INITIAL FIRE SAFETY INSPECTION REPORT

Fakir Fashion Ltd (Extension - 3)

RSC ID: 24847

Date: 05 February, 2024

Table-6: Shed-16: Single-Storied Shed

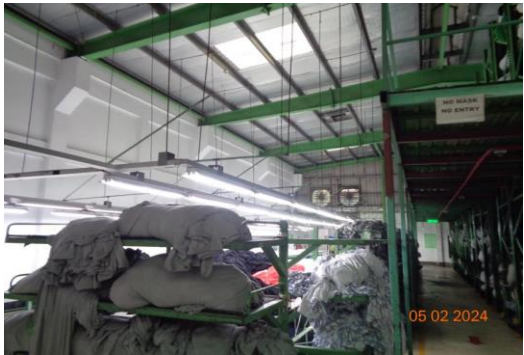
SI No.	Category	Findings	Required Action	Remediation Time Frame
F50	Means of Egress	The gap between intermediate rails was more than 8 inches (200 mm). Location: Shed-16.	Open guards shall have intermediate rails or patterns such that a sphere 200 mm (8 in.) in diameter cannot pass through any opening up to a height of 865 mm (34 in.) RSC Technical Guidelines (Standard)- 6.12.2.	Within 1 month

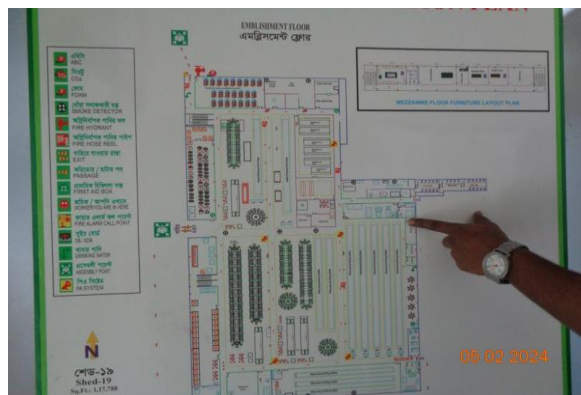
F62	Means of Egress	Travel distance of egress exceeds the allowable limit; approx. 185 ft from east to mid-west exit & approx. 250 ft from the acid-wash section to North-East exit Location: Shed-19.	Reconfigure the egress arrangement so that the travel distance does not exceed 45 m (BNBC 2006 Part 4 Section 3.15.1). Travel distance shall be increased to 60 m (200 ft) where a complete automatic fire detection system portable fire extinguishers & standpipe system is provided and 122 m (400 ft) where a complete automatic sprinkler system is provided. Or, Provide required additional exits.	Within 3 months
-----	-----------------	---	--	-----------------

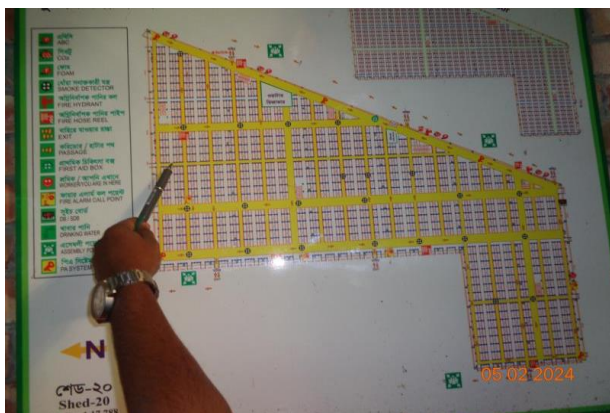
F68	Means of Egress	Travel distance of egress exceeds the allowable limit; approx. 185 ft from North-East exit to North-West Location: Shed-20.	Reconfigure the egress arrangement so that the travel distance does not exceed 45 m (BNBC 2006 Part 4 Section 3.15.1). Travel distance shall be increased to 60 m (200 ft) where a complete automatic fire detection system portable fire extinguishers & standpipe system is provided and 122 m (400 ft) where a complete automatic sprinkler system is provided. Or, Provide required additional exits to maintain the required travel distance.	Within 3 months
-----	-----------------	---	--	-----------------
